To: Rob Balland, PE
From: Pat O'Mahony, Associate Planner; 910-341-0189
CC: File;
Date: 12/18/2019
Re: Tru Colors Brewery TRC Rev. 1

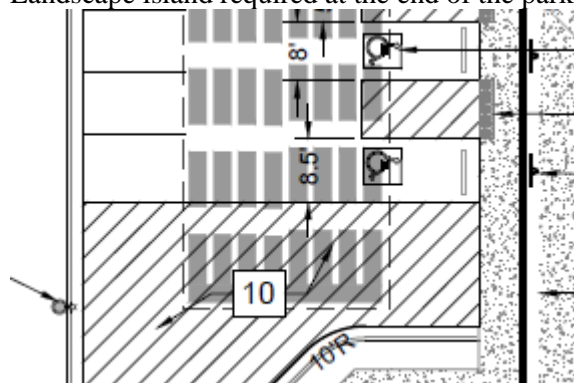
- Surface parking shall be located to the side or rear of buildings or in the interior of a block and shall be prohibited in front of buildings. Surface parking shall not be located along rights-of-way except for alleys.
 - As previously discussed, site will require subdivision of parking lot area prior to construction approval.
- Trash containment areas shall be located within a building where possible.
 - **The enclosure shall be at least one (1) foot taller than the highest point of the trash receptacle. Please provide this note on the plans.**
- Consecutive parking spaces shall incorporate landscaped islands at the ends of all parking rows and within the rows, such that no parking space is located more than one hundred twenty (120) feet from a planting island or peninsula.
 - Landscape island required at the end of the parking row shown below:
